Seismic Walkdown Checklist (SWC)

Equipment ID No. I-1605-95-SPB Equip. Class¹² ZO

Equipment Description SOLID STATE PROT SYS CAR-TEN B

Location: Bldg. CONTROL Floor El. 220 Room, Area 165

Equipment ID No. 1-1805-53-ABD Equip. Class¹² 1

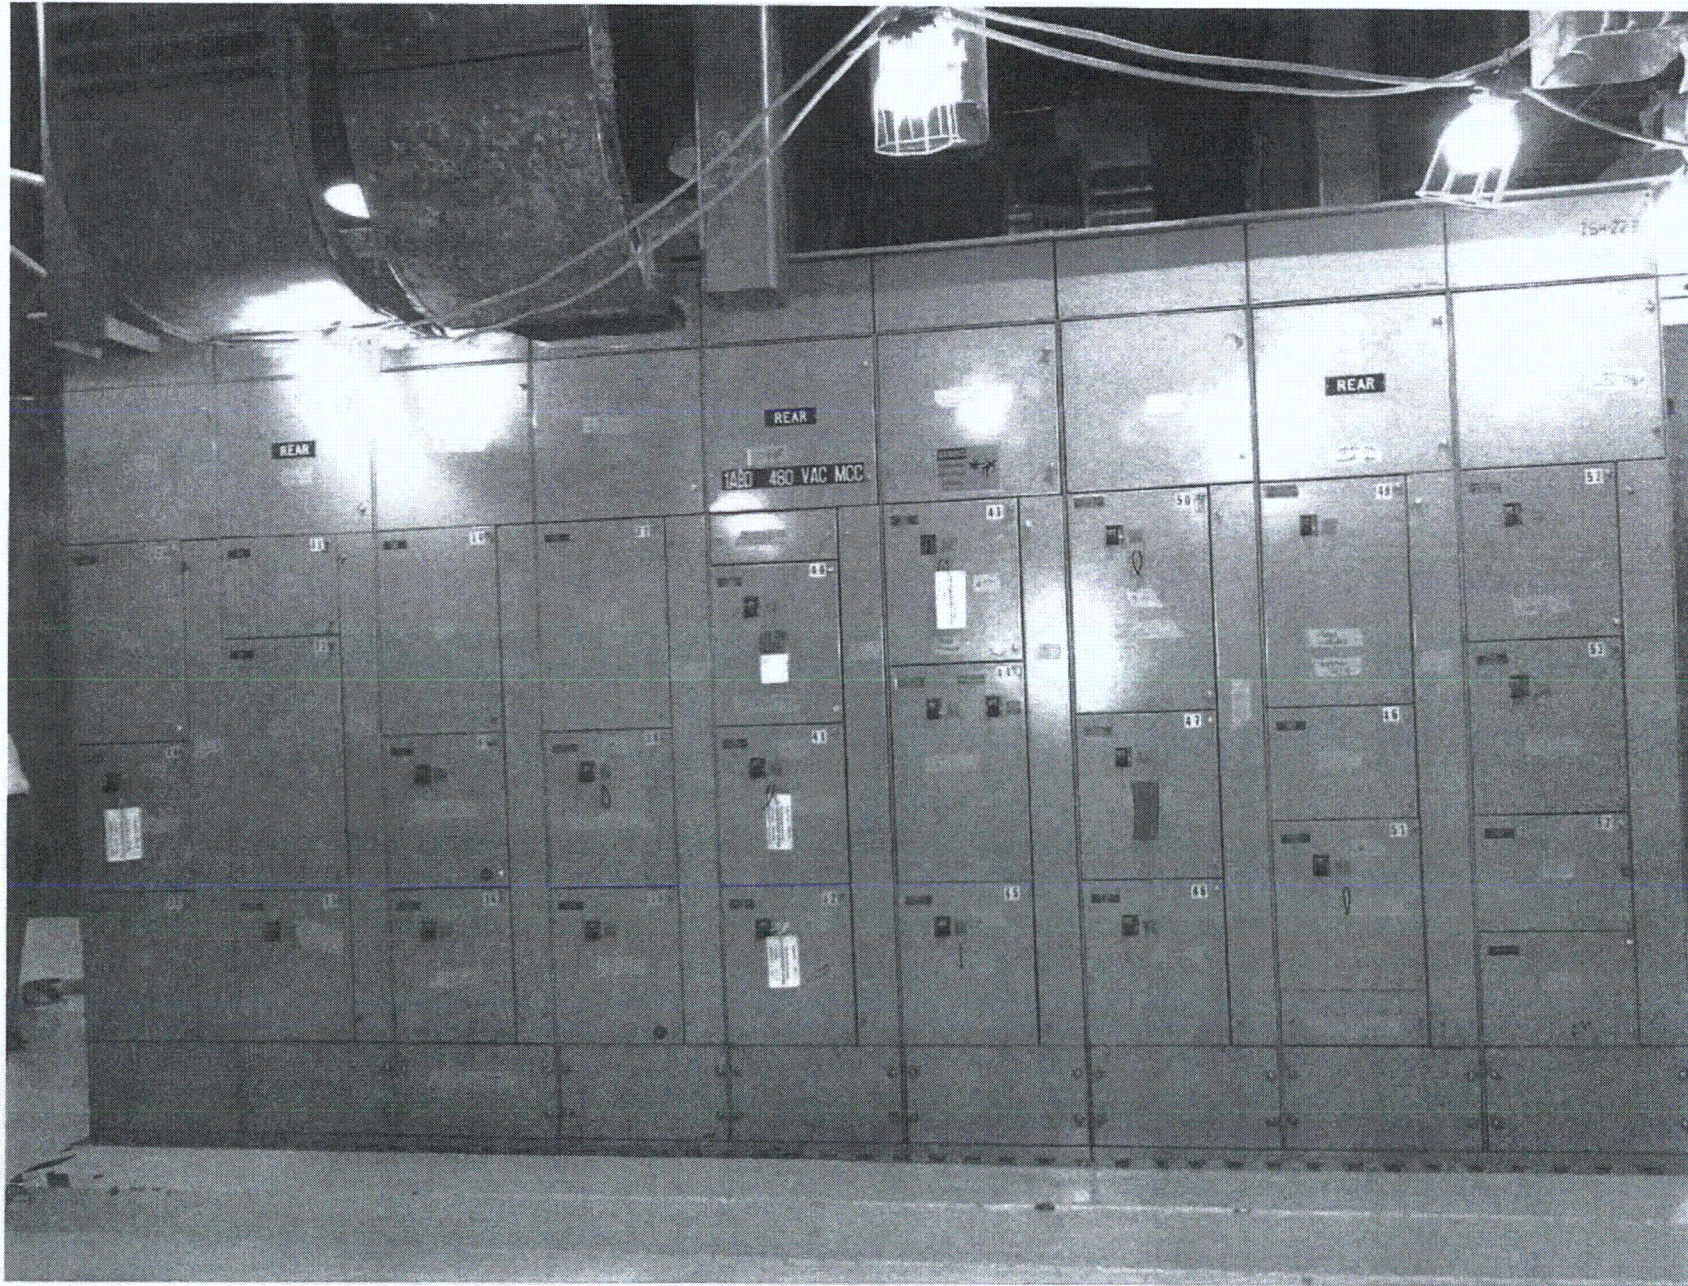
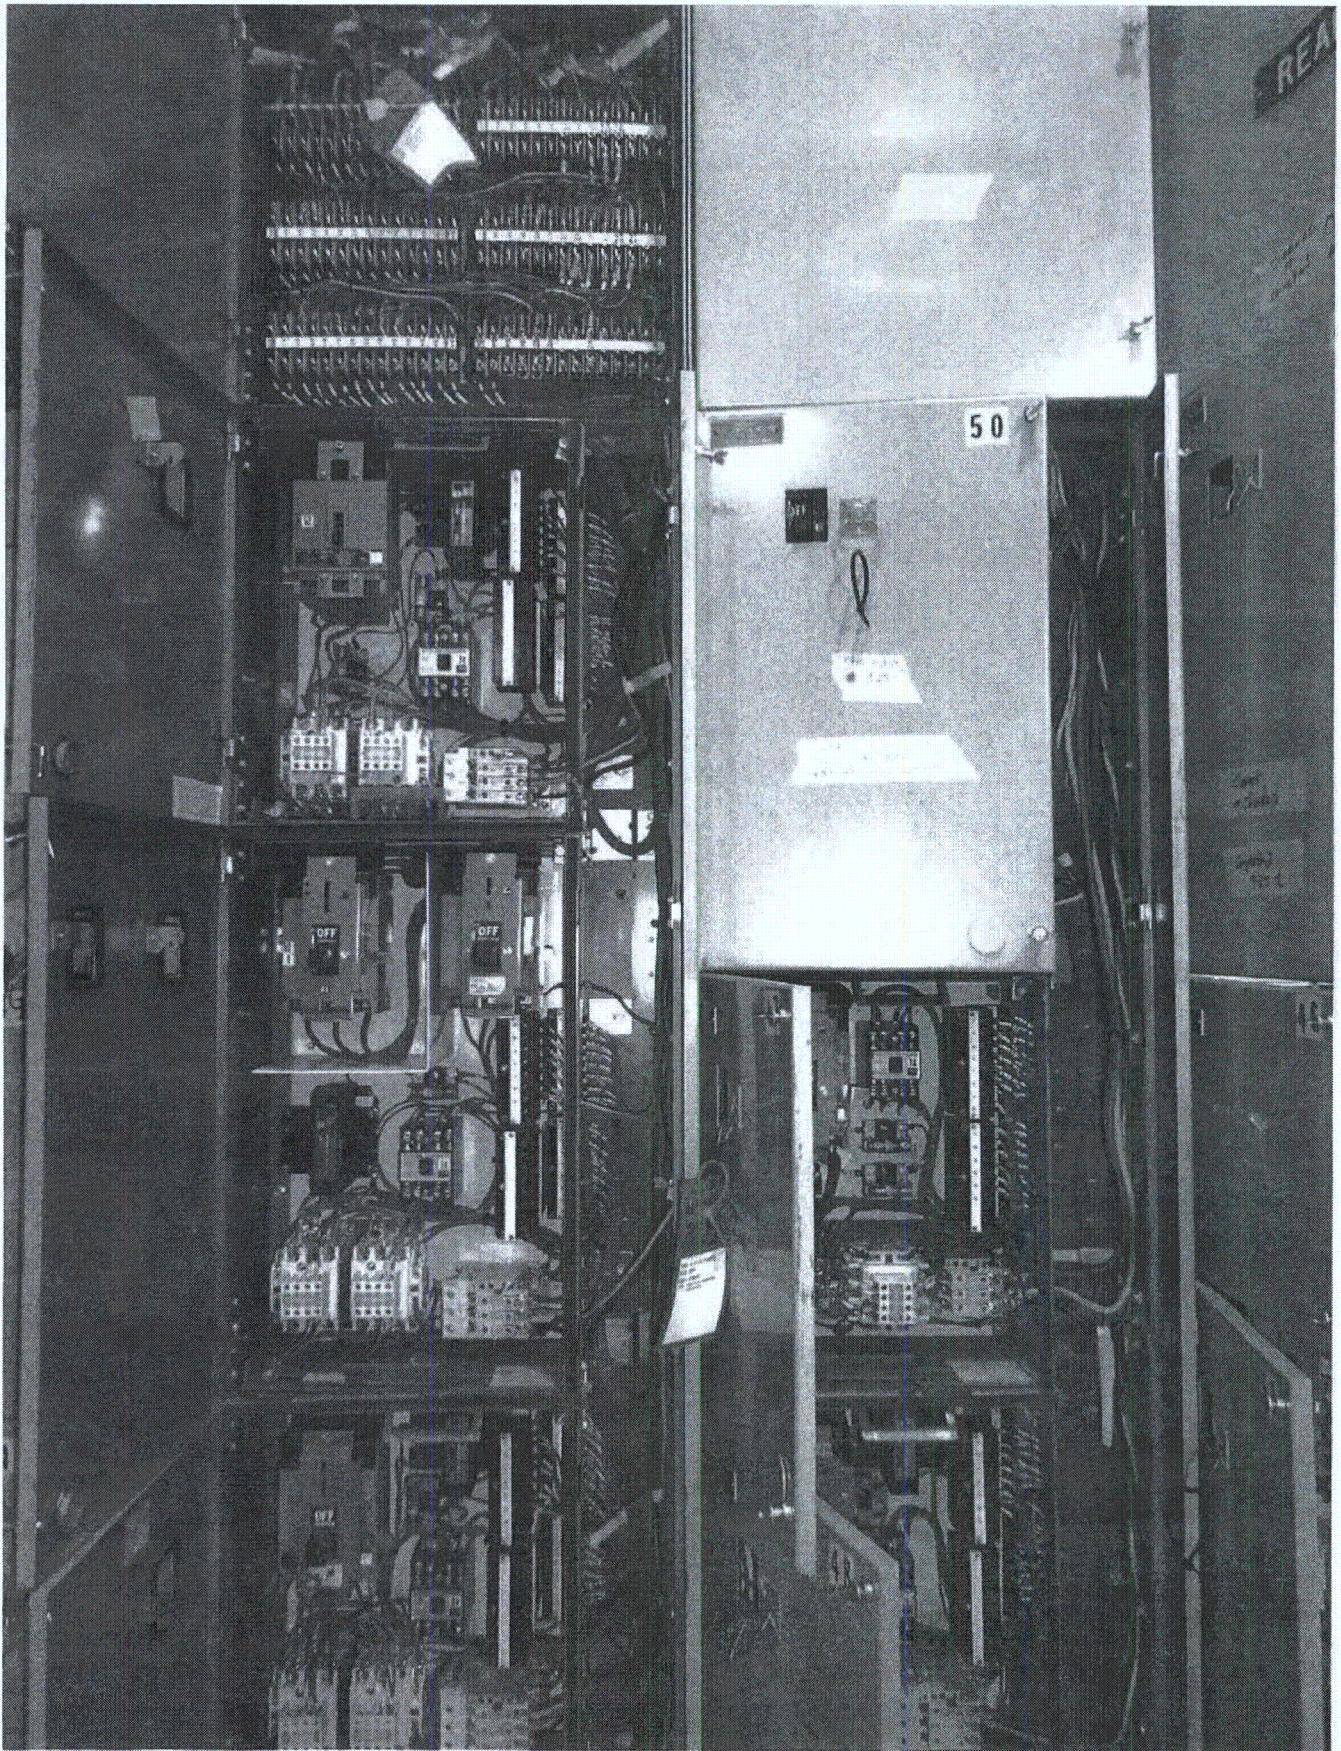
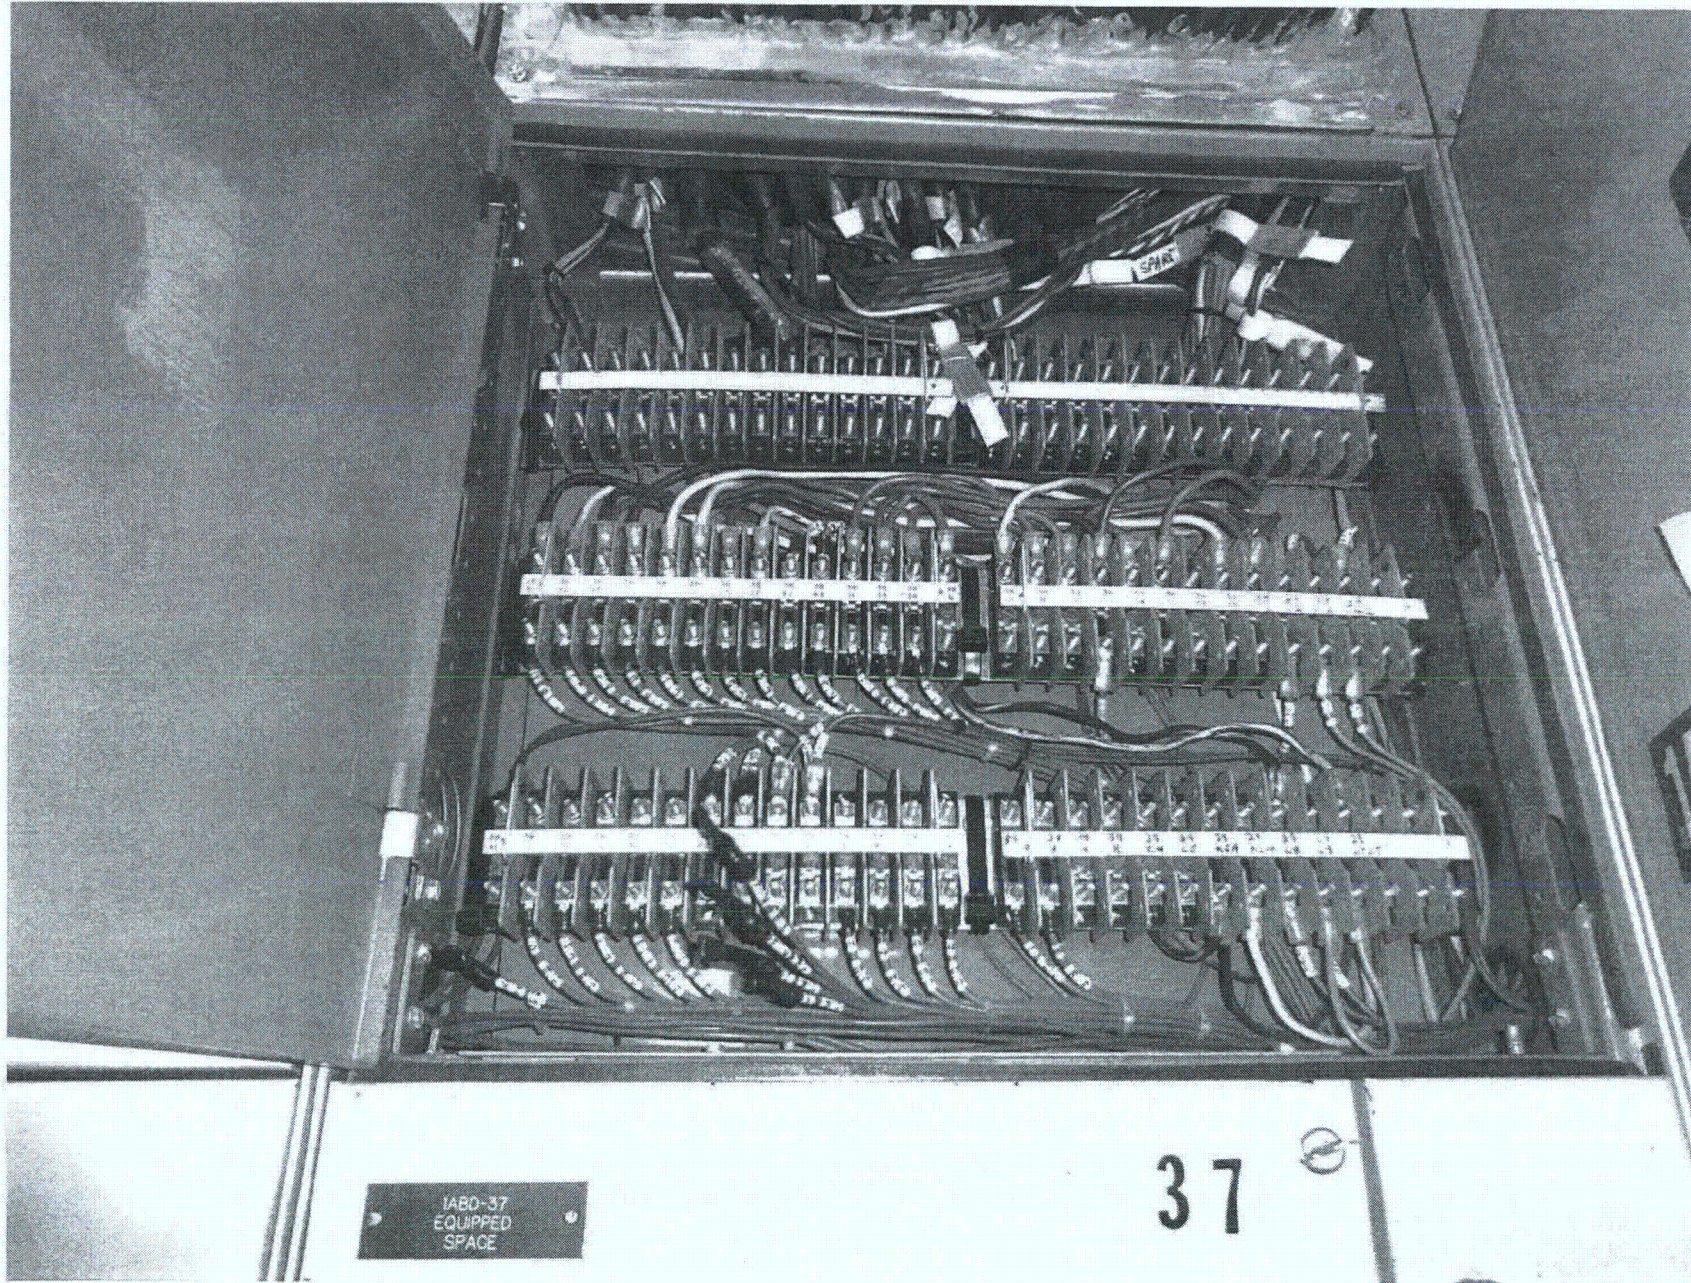
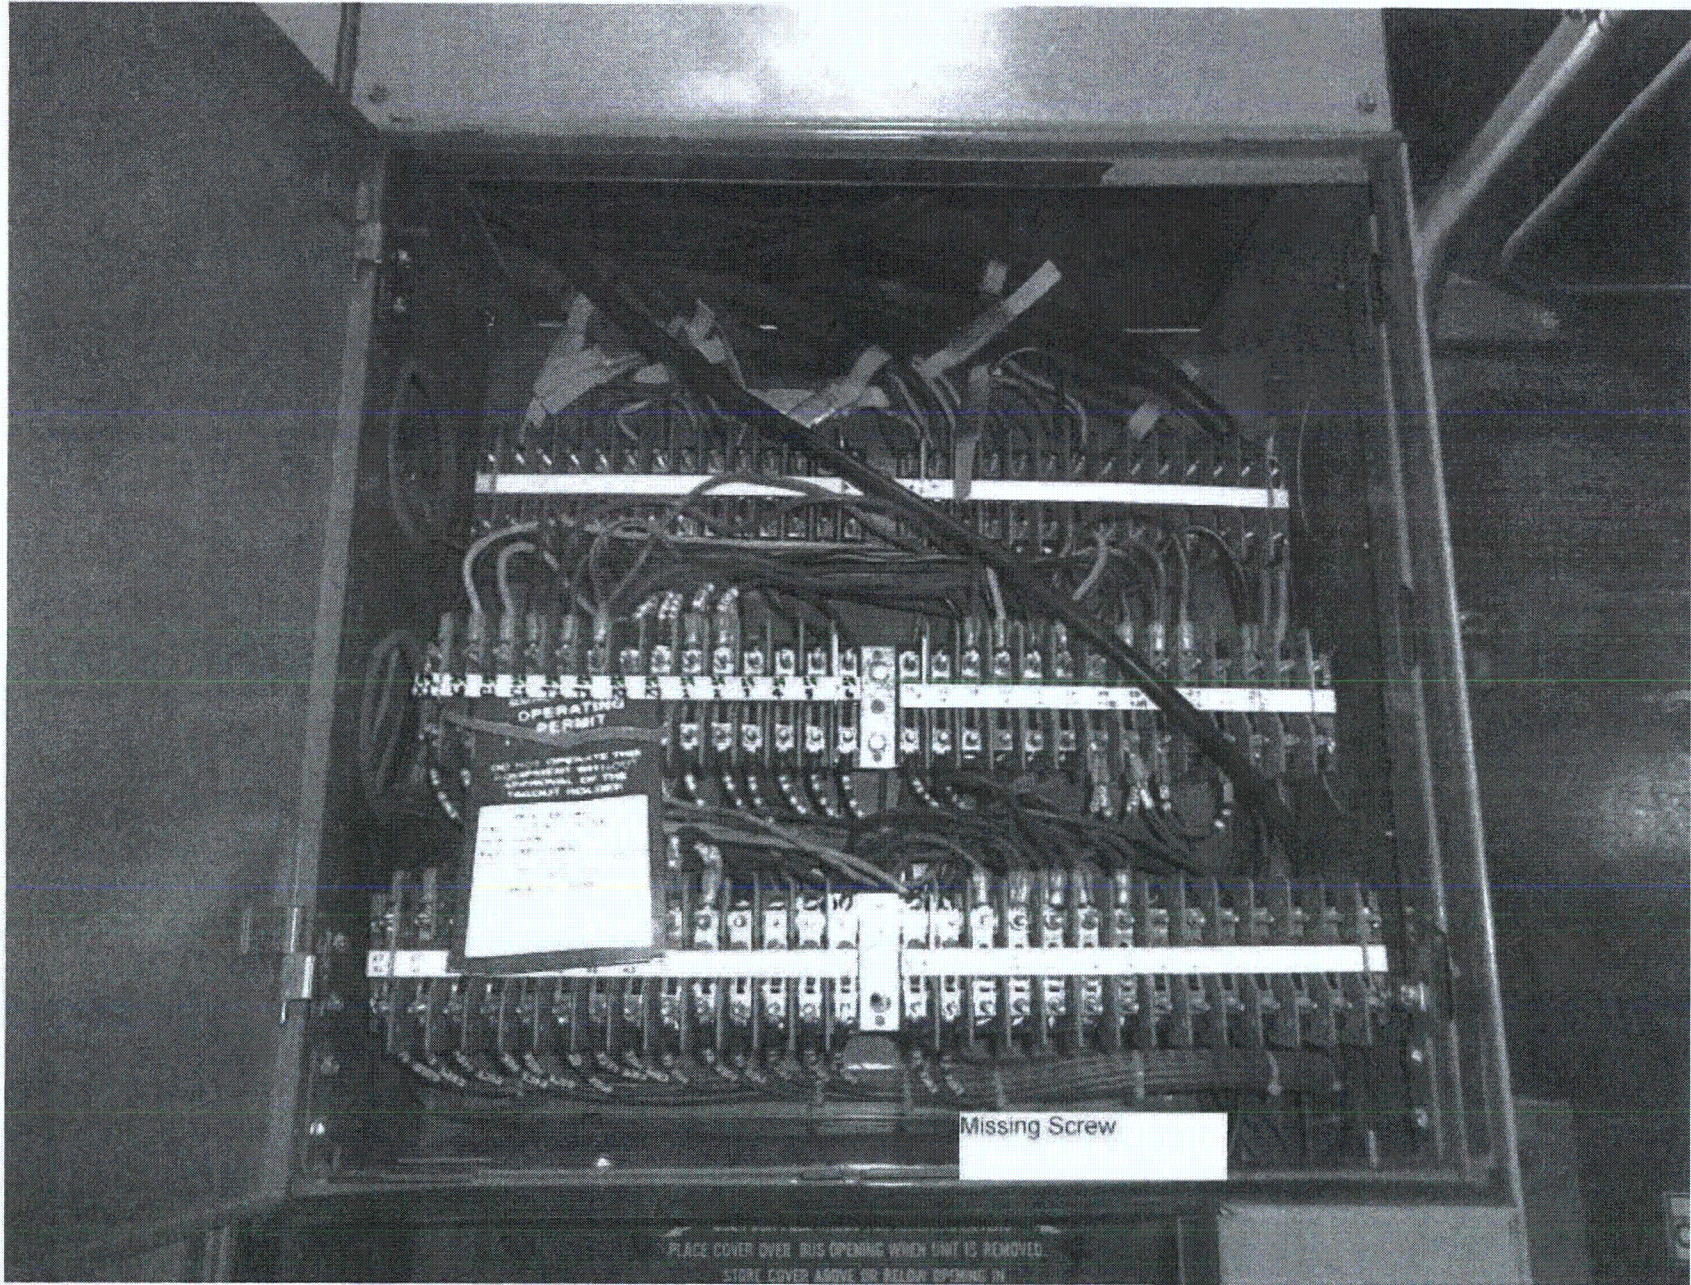
- ① There was found some missing nuts and screws used to secure cover plates and protective covers. The seismic walkdown team judged that these findings do not represent an operability or vulnerability concern.
- ② There was found some missing screws used to secure terminal blocks. The seismic walkdown judged that this condition needs to be evaluated for seismic vulnerability.

Both findings were documented on the condition report 325343.
